Access Compliance Report

Public Rights-of-Way

(Curb Ramps)

Intersection ID: 12560	Main Street: WILKINSON_BV	Cross Street: WEYLAND_AV	Location: NW
ADA ID: 5161DEDD69FB	Ramp Type: Perp	Initial Pass/Fail: Fail	Overall Compliance: No
Severity Score: 10			
Codes/Mitigation Info/Possible Solution		Field Measurements/Component Compliance

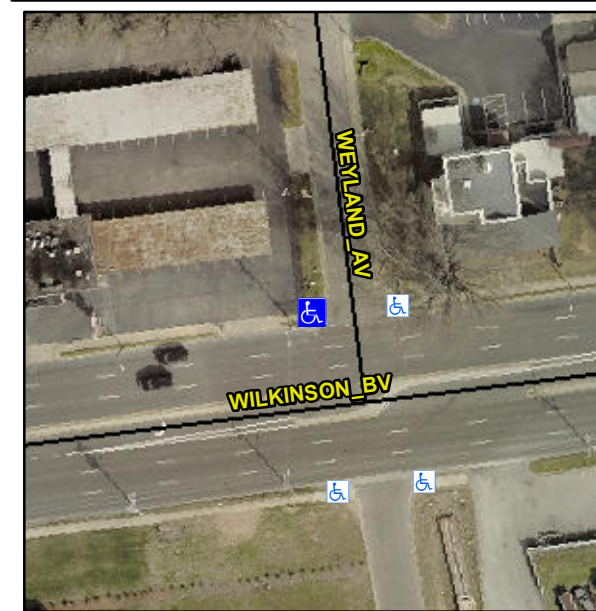
Not Found, R304.5.1, R304.5.3

Compliance	Description	Data	Compliance	Description	Data
N/A	Ramp Length (in)	54.5	Yes	Ramp Slope (%)	8.1
No	Ramp Width (in)	37.0	No	Ramp XSlope (%)	4.2
N/A	Flare Type LT	N/A	N/A	Flare Type RT	N/A
N/A	Flare Slope LT (%)	N/A	N/A	Flare Slope RT (%)	N/A
N/A	Flare Traversable LT?	N/A	N/A	Flare Traversable RT?	N/A
N/A	Landing Length (in)	N/A	N/A	DWS Provided?	N/A
N/A	Landing Width (in)	N/A	N/A	DWS Contrast?	N/A
N/A	Landing Slope (%)	N/A	N/A	DWS Length (in)	N/A
N/A	Landing X Slope (%)	N/A	N/A	DWS Full Width?	N/A
N/A	Landing Curb? (Y/N)	N/A	N/A	DWS Offset (in)	N/A
N/A	Shared Landing?	N/A			
N/A	Gutter Ponding?	N/A	N/A	Gutter Slope (%)	N/A
N/A	Gutter Lip Ht (in)	N/A	N/A	Gutter X Slope (%)	N/A
N/A	Painted X Walk1?	No	N/A	Painted X Walk2?	N/A
	X Walk 1 Direction	To E		X Walk 2 Direction	N/A
N/A	X Walk 1 Width (in)	N/A	N/A	X Walk 2 Width (in)	N/A
	X Walk 1 Slope (%)	2.8		X Walk 2 Slope (%)	N/A
	X Walk 1 X Slope (%)	3.1		X Walk 2 X Slope (%)	N/A

Remove & Replace Entire Ramp.
